ATTACHMENT C

Tree Inventory, Assessment, and Protection Report

14 Fourth Street
Los Altos, CA 94022

May 19, 2022
Revised August 4, 2022

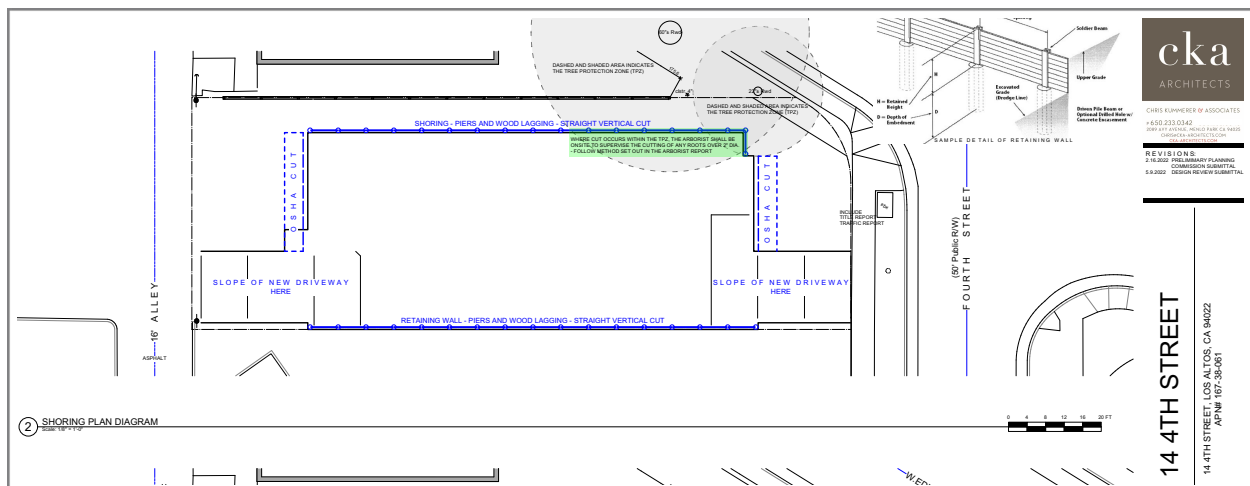
B. Staff has concerned <sic> that the arborist did not fully considered <sic> impacts from the basement's excavation to the trees. As the requested excavation/shoring plan provided comments 5G.a above, the subject arborist shall update the arborist's report to discuss the tree protection measures from the excavation/shoring plan.

MCA: The applicant provided the A1.5 sheet and the shoring plan as provided below:

I have reviewed the plans regarding the proximity of the trenching and shoring adjacent to the trees.

I have suggested within the report in the “Expected Impacts”, “Tree Protection” and “Recommendations” sections to pre-trench and selectively remove roots as necessary. TO reiterate Recommendation #4 states the following:

It is the responsibility of the owners or contractors to schedule meetings and monitoring and to adhere to the recommendations. The proposed shoring encroaches six and ten percent into the suggested TPZ and is not expected to compromise the health or integrity of the trees.
